Re: Response to NSW Environment Protection Authority submission comments - Redbank Power Station Restart - air quality impact assessment, greenhouse gas mitigation plan and climate change adaptation plan

1 Air quality impact assessment

2 Greenhouse gas assessment

3 Climate change adaptation plan

Figure 1.1 Diesel burner emissions during boiler start-up – SO₂, NO_x and particulate matter

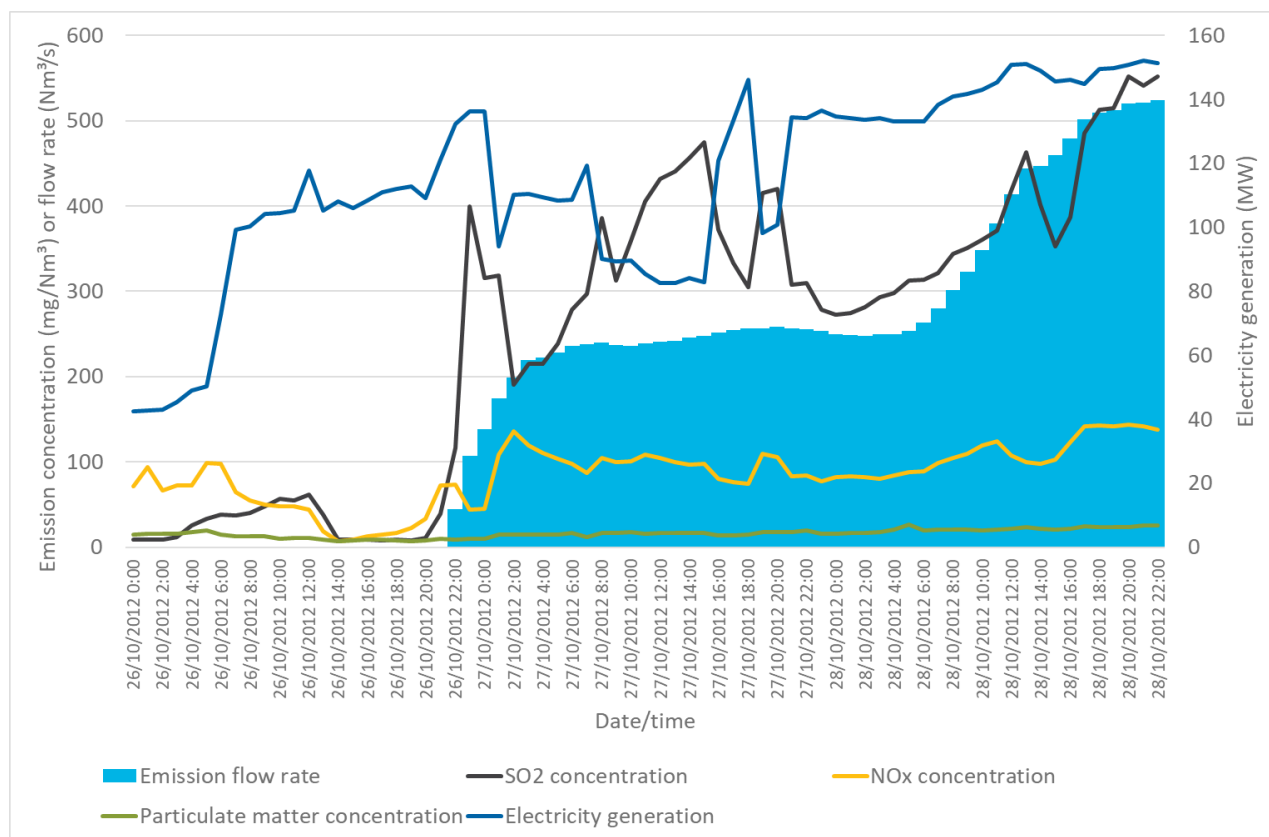
h) The proponent must revise the AQIA to include an assessment of potential impacts for proposed diesel fuel.

Diesel fuel is proposed to be used during plant start-up. However, as assessment of potential impacts from proposed diesel fuel has not been provided.

Verdant Earth has noted that diesel will be used for an average of 40 hours per year which accounts for two outages per year (one minor and one major). Additional diesel may be used during unpredicted outages.

To understand the potential emissions during the operation of diesel fuel burners, Verdant Earth has provided historical CEMS data from the project corresponding to a noted start-up phase of the boiler that occurred in October 2012. Emission concentrations of SO₂, NO_x and particulate matter are illustrated in Figure 1.1 relative to stack emission flow rate and boiler electricity generation.

Figure 1.1 shows the following:

- The phase of diesel burner operation begins after the recommencement of stack emission flow rate measurements on 26 October 2012 and continues until the ramp up in BDT/coal use and increasing electricity generation on 27 October 2012.
- During the period of diesel combustion, emission concentrations of NO_x, SO₂ and particulate matter are less than 98 mg/Nm³, 62 mg/Nm³ and 20 mg/Nm³, respectively.

Relative to the modelling scenarios presented in the AQIA, the following is noted:

- The modelled expected case biomass combustion emission concentration for NO_x was 192.5 mg/Nm³, which is higher than the measured concentration during diesel combustion of 98 mg/Nm³. Therefore, the predicted ground-level concentrations for NO₂ for the expected case biomass combustion can also be viewed as conservatively high for periods of diesel combustion emissions.

- The modelled expected case biomass combustion emission concentration for SO₂ was 32.7 mg/Nm³, which is approximately 1.9 times lower than the measured SO₂ concentration during diesel combustion of 62 mg/Nm³. On review of the model predicted 1-hour maximum ground level SO₂ concentrations presented in the Table 8.3 of the AQIA, a doubling of the predicted maximum 1-hour average SO₂ concentrations would not change the predicted compliance with the applicable NSW EPA impact assessment criteria. It is reminded that the operation of the diesel burners would be an infrequent occurrence at the power station.

- The modelled expected case biomass combustion emission concentration for particulate matter was 6.2 mg/Nm³, which is approximately 3.2 times lower than the measured particulate matter concentration during diesel combustion of 20 mg/Nm³. It is noted that the modelling for the regulatory worst case scenario adopted a particulate matter emission concentration of 50 mg/Nm³. All predicted incremental particulate matter concentrations for the expected case biomass combustion and regulatory worst case scenarios are low, and this would therefore be applicable for periods of diesel burner operation.

On the basis of the comparison of historical recorded stack emission concentrations during diesel combustion with quantified emissions for the combustion of biomass material at the power station, it is considered that the air quality impact assessment provides suitable range in modelled emission rates to account for potential ground level concentrations during the operation of the diesel burners during shut-down/start-up periods. It is considered that this comparison is conservative on the basis that diesel burners would only be used for approximately 40 hours of the year.

Figure 2.1 Feedstock throughput

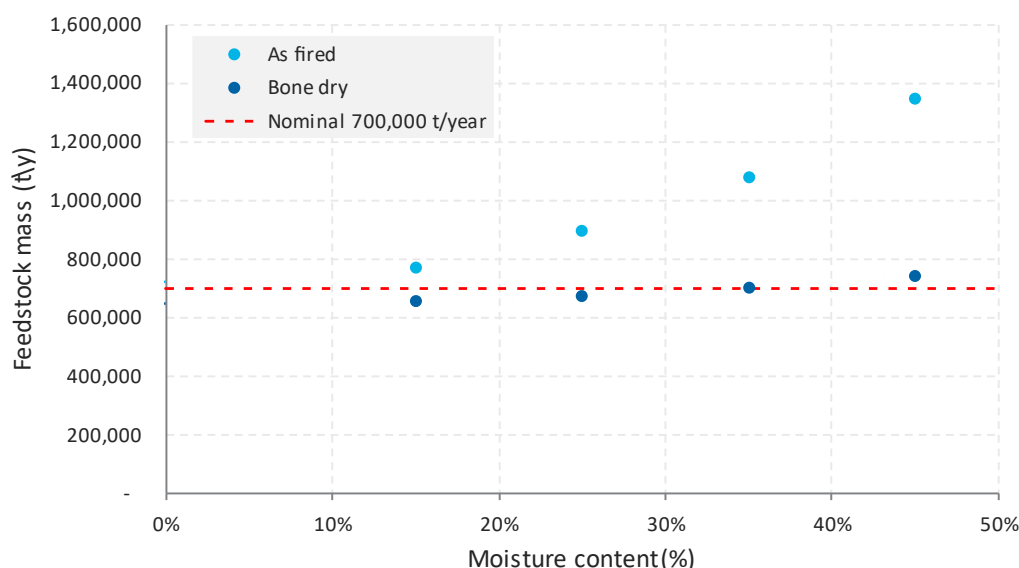
c) the proponent must provide further information and an explanation on whether the mass of biomass required by the power station is fixed or varies. Further information is needed to understand the relationship between the energy content of the biomass and tonnes biomass required per annum. If the mass of biomass increases or decreases the impact this has on scope 1 and 3 emissions should also be commented on.

The technical specification is 850,000 tonnes per annum at 25% moisture content. However, it is unclear how this varies with biomass energy and moisture content. If it does vary further information and justification should be provided as described above. Consideration should also be given on the impact this will have on ash production and how this will relate to third party processing and transport.

Table 2 of the B&PPS report gives the mass of feedstock samples (‘as fired’ and ‘bone dry’), with a nominal throughput of 700,000 t/year of dry wood, as shown in Table 2.1 and Figure 2.1. The ‘as fired’ samples have moisture contents ranging from 15% to 45%.

The GHG calculations are based on effective dry feedstock mass (also requested by EPA. However, the boiler efficiency changes with moisture content due to design conditions and limitations in the steam generator. For the different feedstock moisture levels in Figure 2.1, B&PPS (2021) gives the output of the generation system, stated as the maximum continuous rating (MCR) of the steam generation and hence the plant power output. The data, summarised in Table 2.2, show that the MCR reduces from 100% at 15% and 25% moisture, to 85% at 45% moisture.
